# **Melbourne Metro Rail Project**

## **Inquiry and Advisory Committee**

Expert Evidence Submission  
Urban Design

11 August 2016

Figure 1: *EES Appendix P – Ground Movement and Land Stability – Fig 9-2 (page 89)*

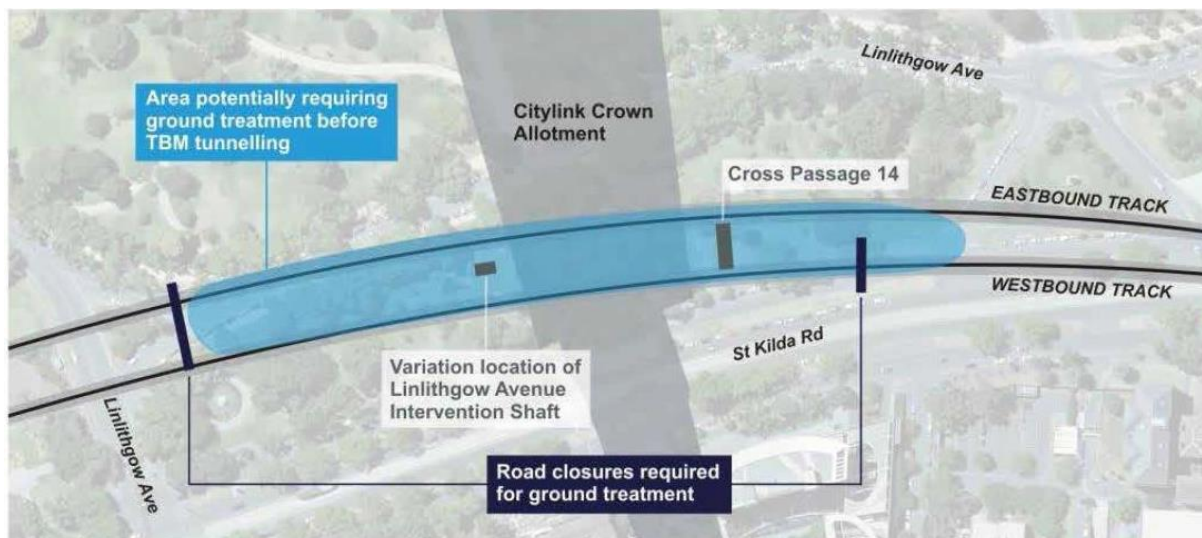
I do not support the proposal for the vertical alignment of the tunnel below Domain Parkland to be above CityLink tunnel. In this option the Metro Rail tunnel would be located close to the natural ground levels within Tom's Block portion of Domain Parklands. *EES Chapter 16 Landscapes and Visual pages 22-23 states 'A total of 55 trees (including up to 30 mature trees) could potentially require removal due to ground stabilisation works at the shallow funnelled section above CityLink Tunnel'.*

*EES Chapter 19 Ground Movement and Land Stability Table 19-7 sub heading Parklands and Waterways (page 28)* indicates that the site could only be remediated not reinstated, if this option is adopted. The assessment is silent on the matter of the effect of the option for Metro Tunnels to be

located below CityLink Tunnel. It would be reasonable to assume that no ground stabilisation would be required for the below CityLink option. This assumption is based on the fact that generally the EES is not calling for ground stabilisation in other parkland areas but only for the area of Tom's Block related to the shallow tunnel (ie over CityLink) option. My concerns regarding the shallow tunnel option not only relate to the tree removals and ground stabilisation but also relate to concerns regarding the legacy ground conditions for newly planted trees to be able to thrive in an area of parkland where ground stabilisation construction works have been undertaken. On this basis, the long term risk in legacy would be that this large area of Tom's Block would, at worst, remain without trees, or possibly, have trees that struggle to reach full potential as they mature. I refer here to *MMRA UDS 4.1.1a para 2 (page 42)* that states “..but soil reinforcement works could limit new tree planting”.

For the above reasons I do not support tunnels above CityLink. Tunnels should be located below CityLink.

**Figure 4: University Square – construction staging with MMRP – showing MMRP proposed works area in northern portion of square and Barry Street**

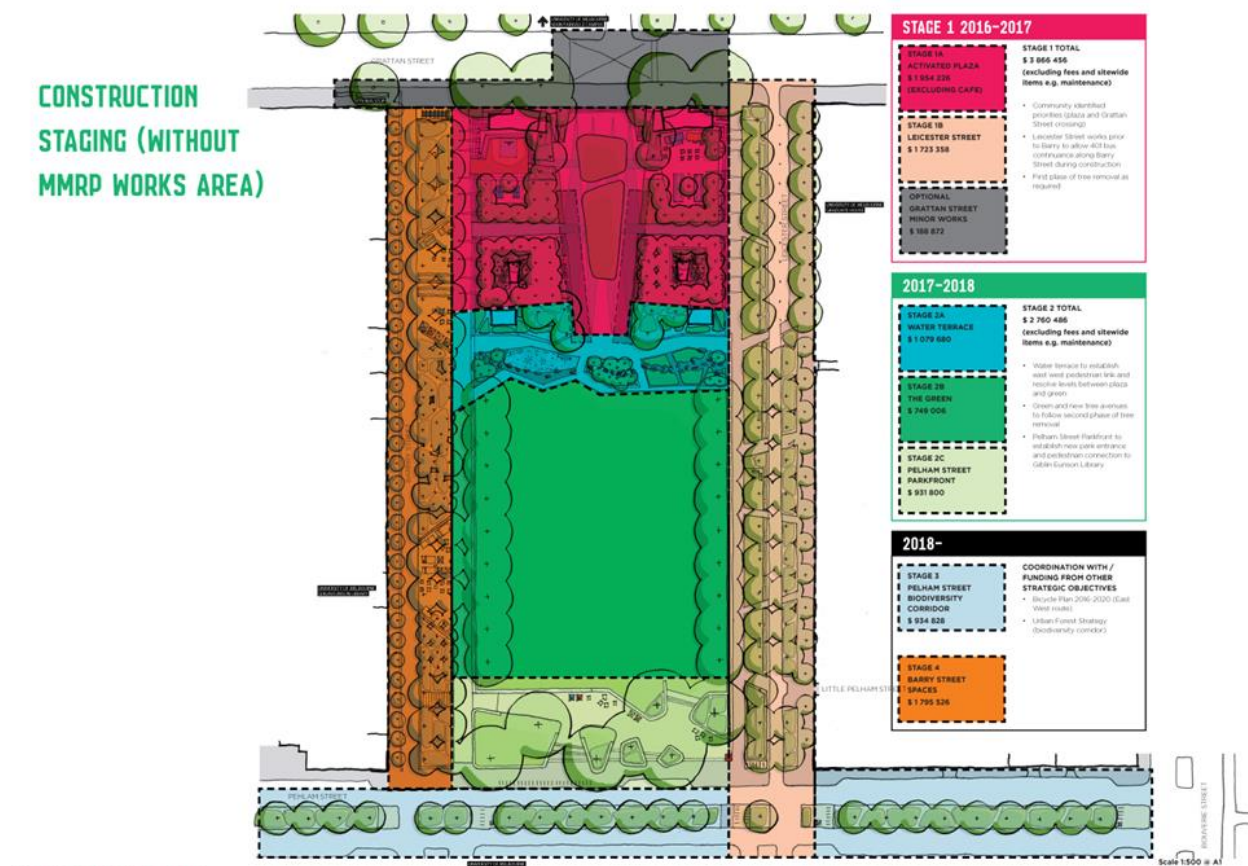
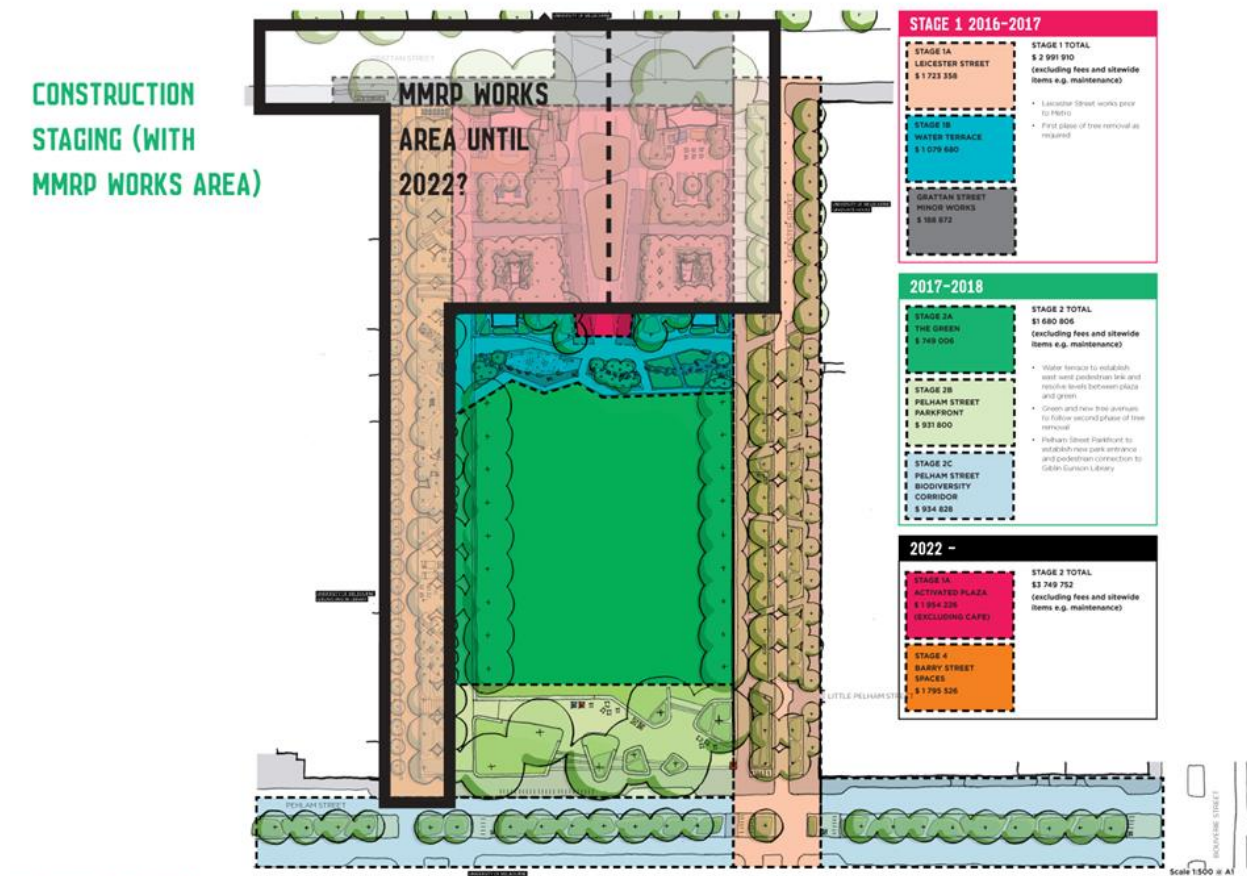
EES Map Book – Parkville Station Precinct Map 5 indicates a range of ventilation structures. These are shown as a number of green dots and dashes along Grattan Street and two significant lines of infrastructure in Barry Street. CoM has developed a Master plan for University Square. (Ref. Fig 3 and Fig 4 below). Ventilation structures on Grattan Street will need to be sensitively integrated with existing infrastructure together with the overall vision and urban design proposals for the future of Grattan Street post construction. CoM's future vision of Barry Street would be significantly compromised by above ground infrastructure of the scale indicated on Map 5. Barry Street is intended to be closed to traffic and become a landscaped pedestrian spine linking UoM's campuses north and south of Grattan Street. MMRA should continue to work closely with CoM and UoM to resolve these matters of detail design. MMRA and the PPP contractor will need to work closely with CoM to ensure all aspects of the design and delivery of University Square are well planned and coordinated.

**Figure 8: Franklin Street (between Victoria/Swanston) – plan of future street layout as proposed in City of Melbourne’s EES submission including location of new CBD North station entry.**

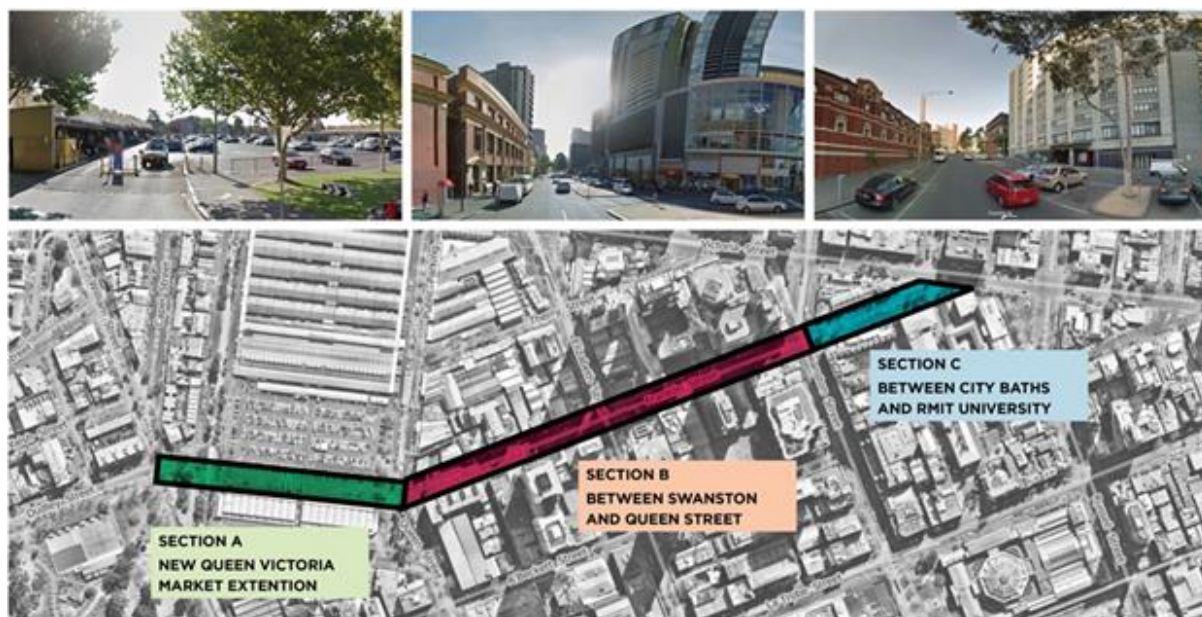
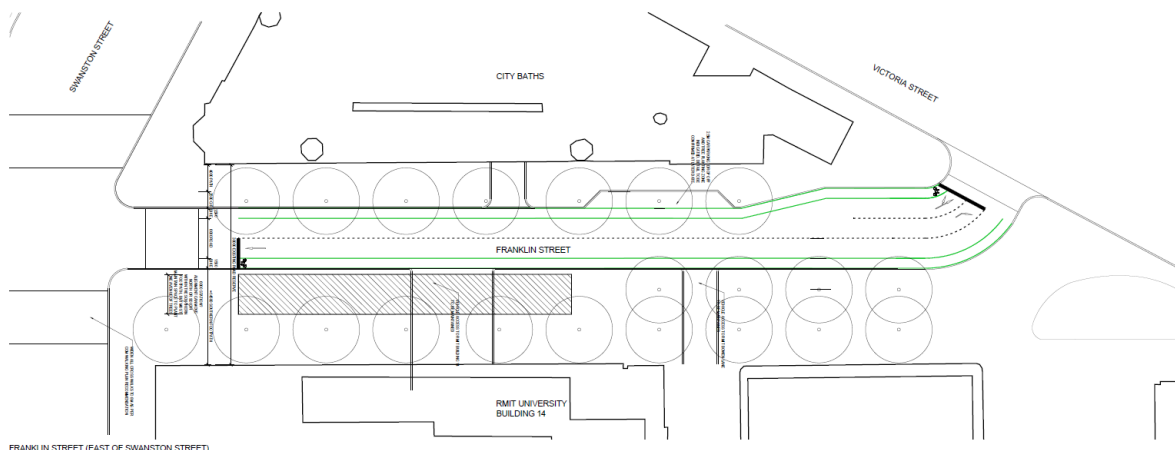
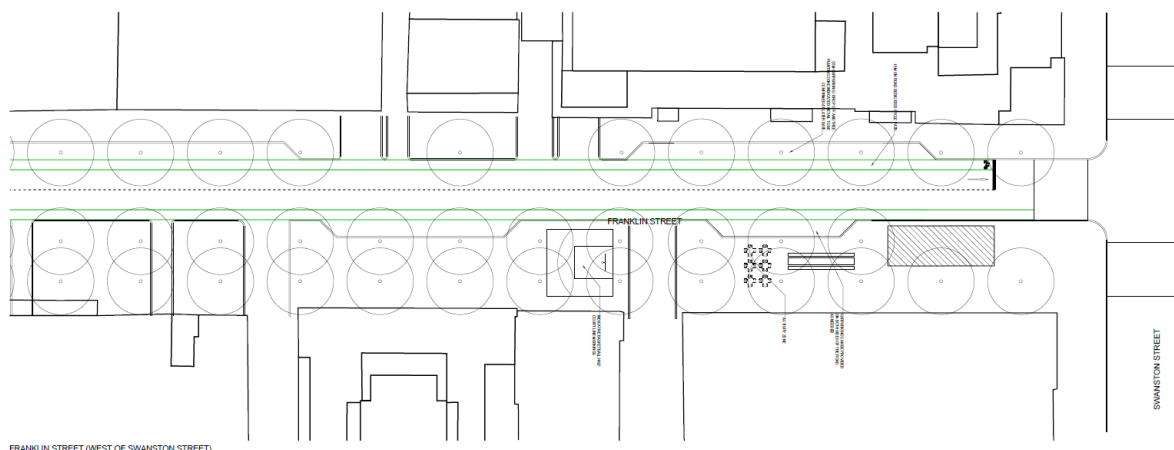
I do not support the closure of Franklin Street between Victoria Street and Swanston Street as per the EES. I note that this is inconsistent with CoM requirements to maintain one lane of traffic and a bike lane in each direction along the length of Franklin Street from Victoria Street to Queen Street. MMRA's Technical Note 012 issued 26/07/16 states that MMRA supports this position and will amend plans to enable the reopening to traffic post-construction. I support this amendment and recommend the design be implemented generally in accordance with CoM schematic layout for Franklin Street in legacy. This layout includes opportunities to reconfigure Franklin Street from its current arrangement dominated by space allocated to car traffic and parking. In legacy, CoM schematic layout shows more generous provision of space for people. Pedestrians will be able to walk comfortably under double row of trees on the south side of Franklin Street that will link the CBD North Station with the renewed QVM precinct. Provision will still be made for some on-street parking but the clear emphasis will shift from a dominance of a street for cars to a street for people. Taking into consideration the greatly increased numbers of pedestrians and increased numbers of residents and visitors in this northern part of the city, it is entirely appropriate to initiate such a reconfiguration of Franklin Street to

- EPR LV1 add State Library Forecourt
- Support for amended proposal to retain Franklin Street for one lane of traffic and one bike lane in each direction in legacy.
- Support for the reconfiguration of Franklin Street as a 'people' focussed street linking CBD North and QVM
- Future proof additional station entries
- Support for the reconfiguration of the southern portion of CBD North precinct to provide greater provision of space for pedestrians together with adequate access for service vehicles and access to properties.
- Integration of all above ground station infrastructure (station entries, ventilation structures etc) with overall streetscape design.
- Retention (in modified form) of existing Council Lane CL0112
- Minimise non-active/non-inhabited service space fronting onto the public realm in streets and lanes.

**Figure 10: CBD South Access Options as per MMRA's EES showing proposed construction vehicle standby areas in Russell Street and Exhibition Street**

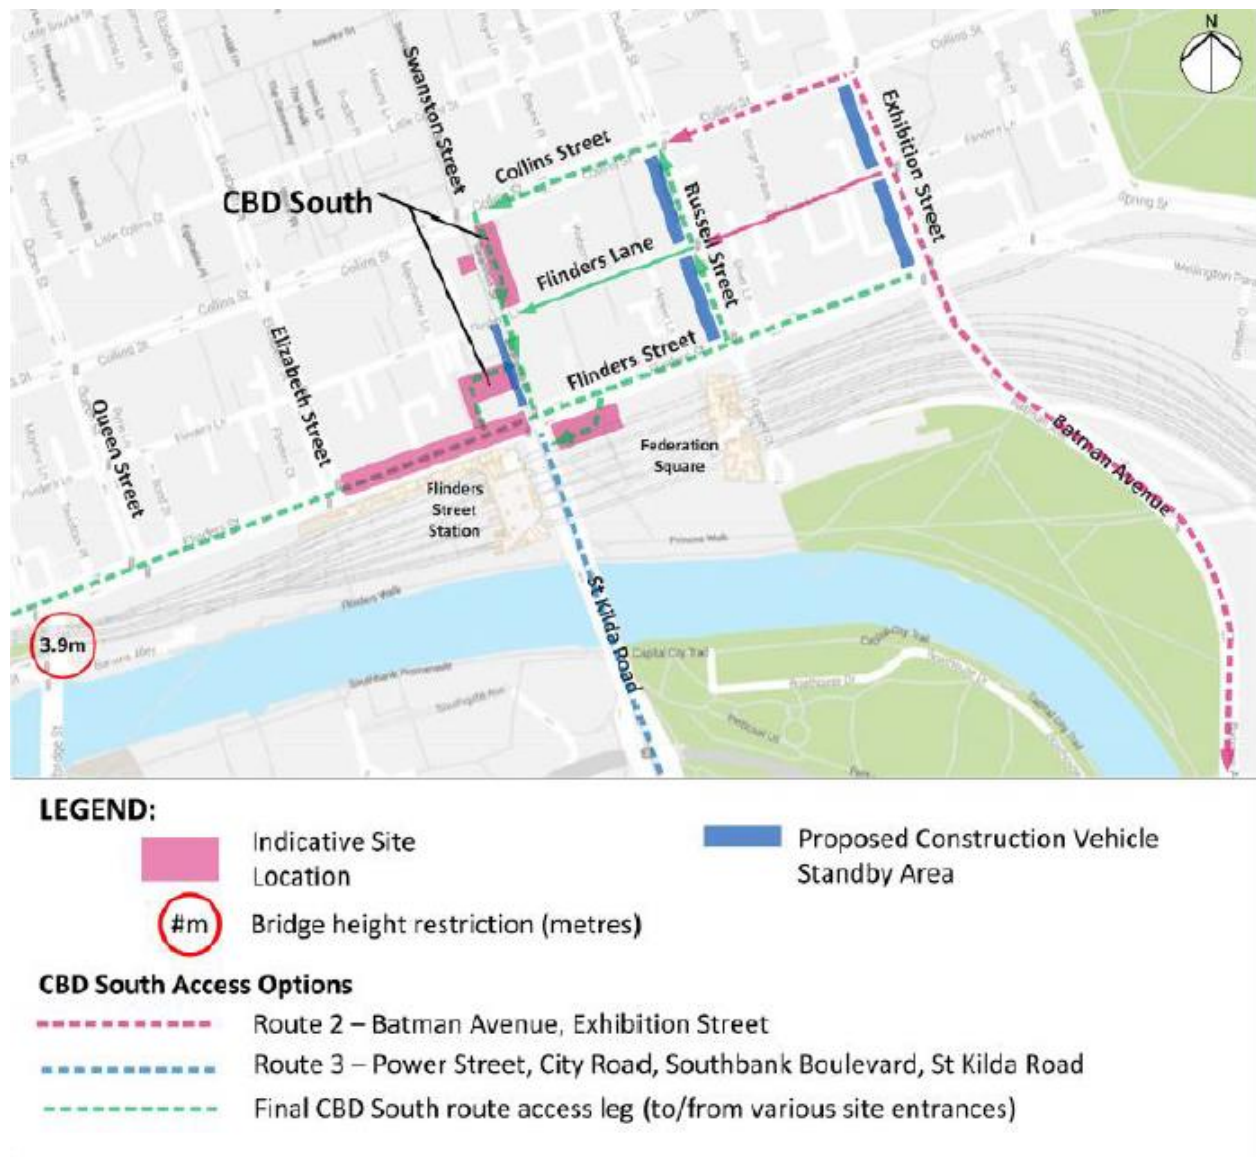
Other CoM expert witnesses will cover construction traffic matters at a detailed technical level but I raise here one area of particular concern that relates to the proposal for construction vehicle standby areas to be located in Russell Street and Exhibition Street between Flinders St/Collins St. These areas marked blue on the relevant Transport map. Large numbers of trucks parked on 'standby' in these streets over extended periods of time is not, in my opinion, an acceptable outcome for the city. MMRA and their PPP contractors should put forward construction management plans that indicate alternative arrangements for 'standby' space for trucks that minimise impact within key CBD streets such as Russell and Exhibition Streets.

**Figure 11: CBD South – City Square Diagram illustrating function layout post MMRP**

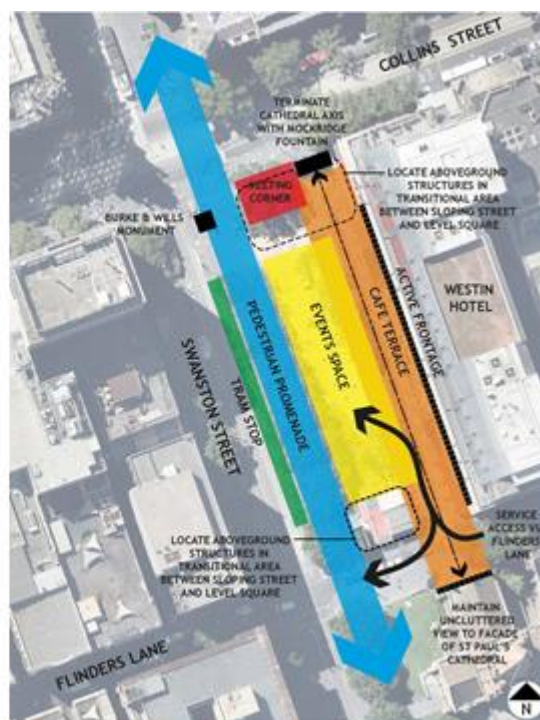
Fig. 11 below, together with the list of dot points below represents my summary of key matters for consideration in the design of City Square:

- Station entry in northern end of square to be set back from Collins Street frontage to allow useable public space similar to that provided currently around the mature Elm tree. Station entry to be off Swanston Street.
